Wisconsin Department of Transportation

Proposal #38: 4610-06-71, WISC 2015 295
Village of Sister Bay
Country Walk Drive – Scandia Road
STH 42
Door County

This is Addendum No. 2, which provides for the following:

Addendum No. 2
 ID 4610-06-71
 Revised Sheet 199
 May 7, 2015

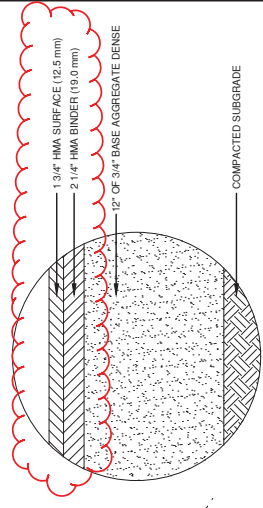
Revised Plan Sheets	
Plan Sheet	Plan Sheet Title (brief description of changes to sheet)
199	Parking Lot – Site plan (revised thicknesses of asphalt layers)
213	Miscellaneous Quantities (revised STH 42 and Mill Rd lot materials, added Temp HMA remarks)
214	Miscellaneous Quantities (added concrete sidewalk, cold weather covering items)
